Jonesboro Historic Preservation Commission **1859 CITY CENTER WAY** January 17, 2023 – 12:00 AM

Agenda

Historic Preservation Commission to consider a change to a Certificate of Appropriateness for Commercial Building – 162 South Main Street; Parcel No. 13241D E006; Renovation of existing residence and property for conversion into a restaurant within the Historic District. Revised design.

Historic Preservation Commission to consider a change to a Certificate of Appropriateness for Obiorah Fields, LLC – 157 South McDonough Street; Parcel No. 13241D H003; Change of exterior color in Historic District. Revised trim color.

EXTERIOR ELEVATIONS

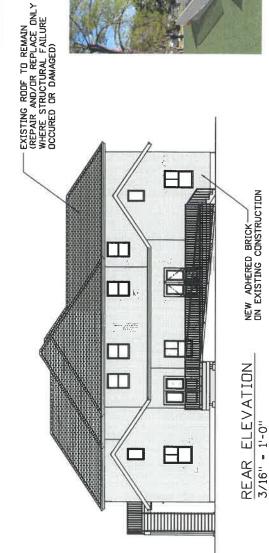
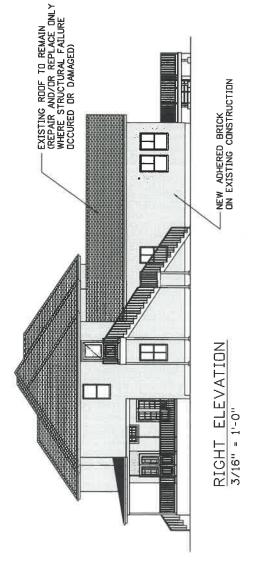
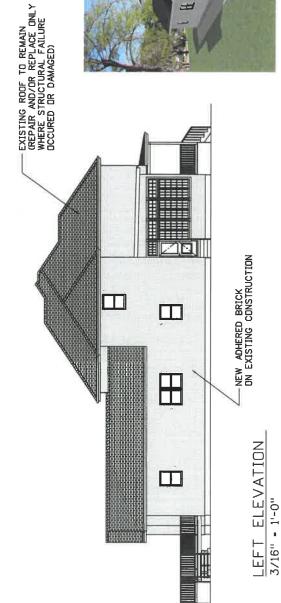
- What color will the window frames now be?
- What will be the new trim color?
- Provide actual color sample of "cloud white" brick for veneer.
- While the brick is a more durable material than the wood siding, they recommend a composite mix of materials (brick, hardiplank, stone, etc.) for more visual interest.

The updated drawings provided by the applicant in December show:

- 1. White brick as still the dominant new exterior material.
- 2. No other color variation, or stone of Hardiplank elements shown.
- 3. An enlarged front porch for sitting.
- 4. A new concrete sidewalk going from the modified front porch to the side yard and the proposed parking lot in the rear.
- 5. All shutters are gone, and the white window trim is now black.
- 6. All other trim remains white.
- 7. Staircase to upper floor to be added to north side.
- 8. Rear deck to be completely replaced and have required ADA ramp addition.
- 9. Small stairs added to south side.
- 10. All present window configurations retained.

An intelligent use of brick, stone, and Hardiplank siding is encouraged to soften the transition of the building from a recognized historic house to a modern and active commercial use.

- Stone around bottom of porch and foundation.
- Minimum 6-inch wide Hardiplank siding (banding) around windows (especially front windows)
- If possible, brick "arches" over front windows for some architectural interest.

Design Review Commission recommendation, 1.4.23: Approval of white brick, but would like to see more variation with the design, especially in the front:

EXTERIOR ELEVATIONS

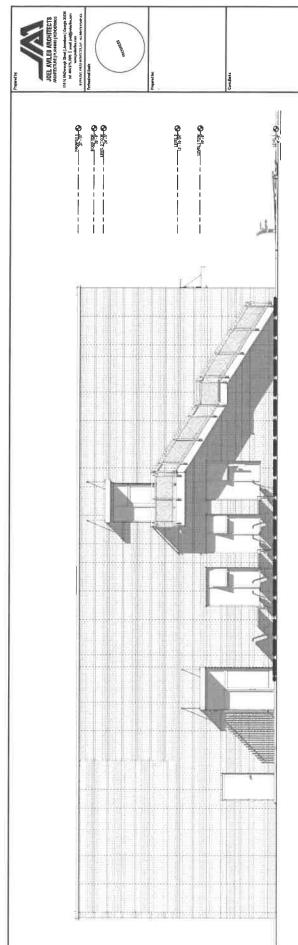
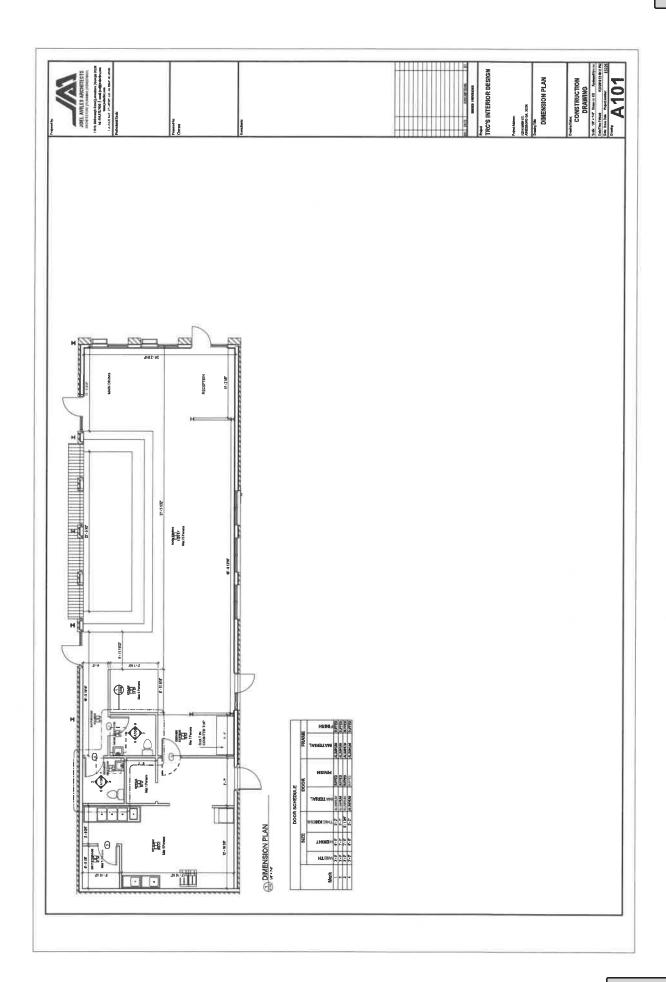
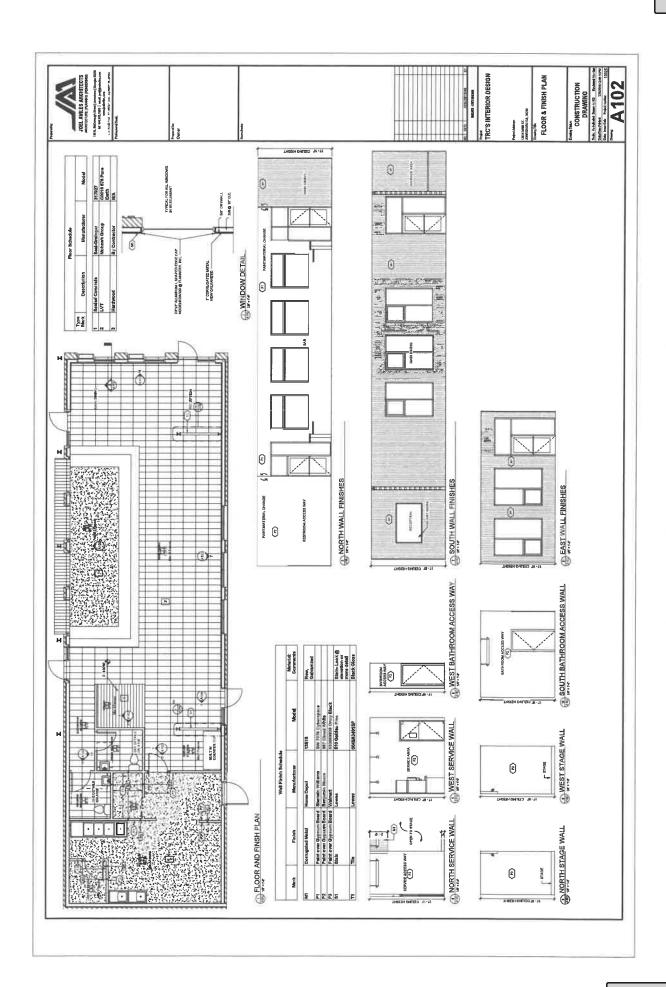
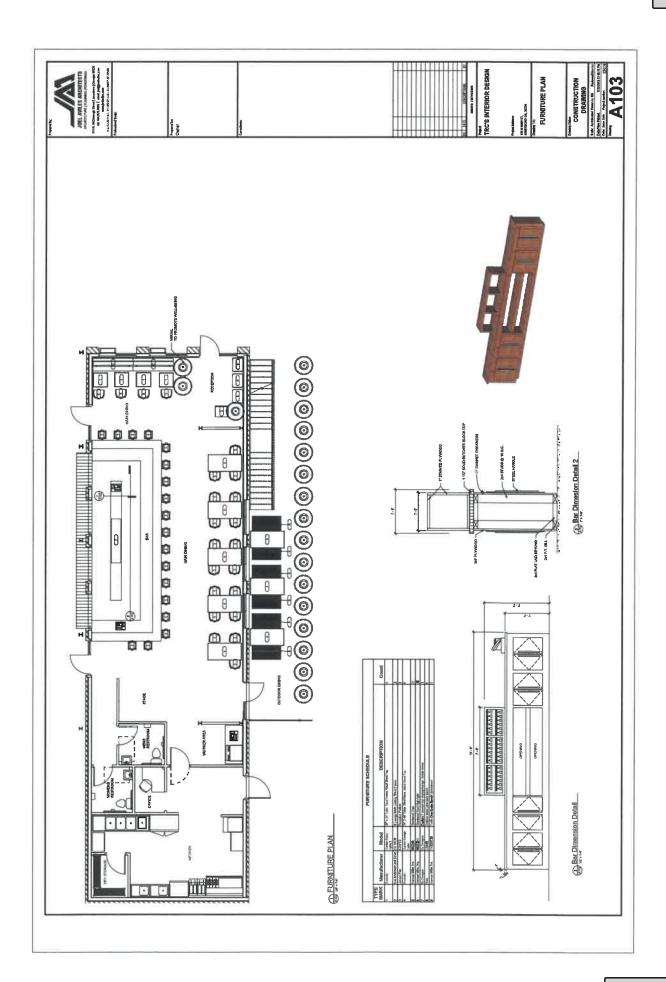
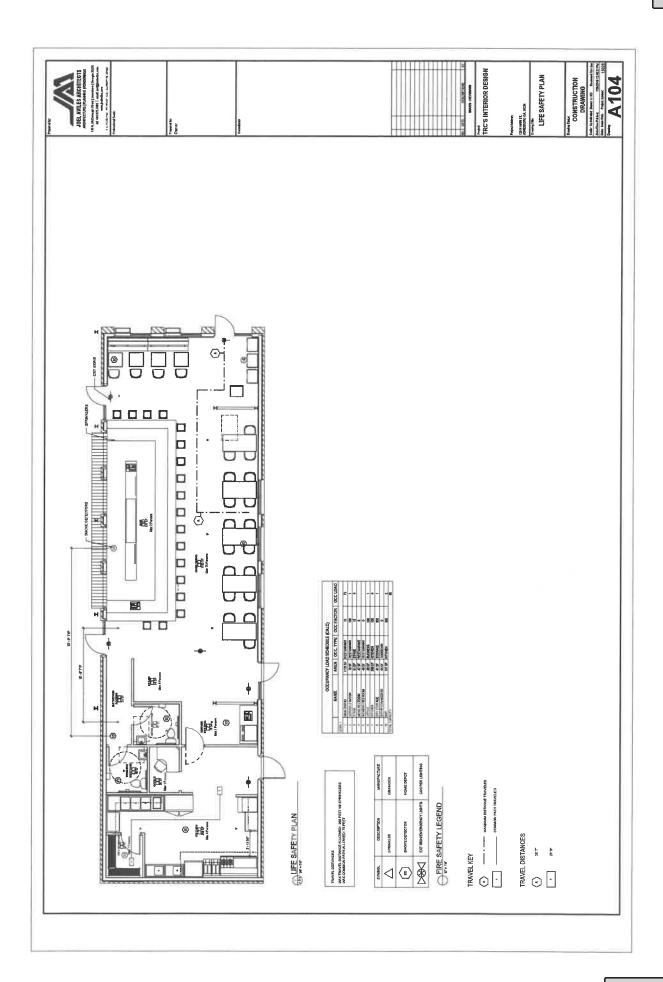
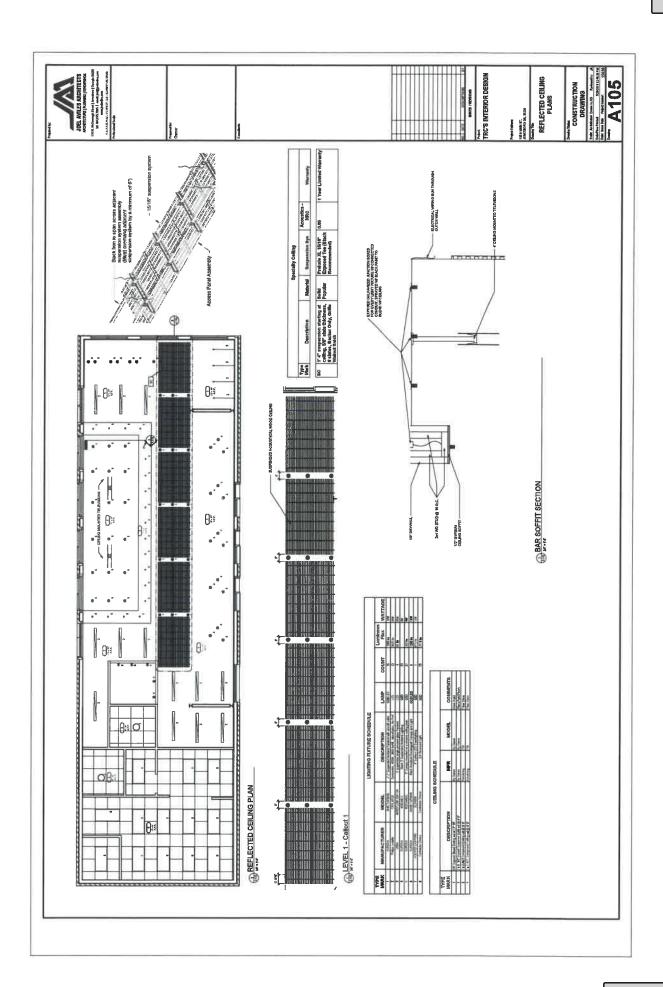
In summary, this will be a quality addition to the downtown. The City Council indicated that they would like to see more variation than just brick, but the rendering does indeed show appropriate proportions of glass, wood, and metal. The design intent for the downtown Historic District is predominantly brick.

Design Review Commission recommendation, 1.4.23: Approved as presented.
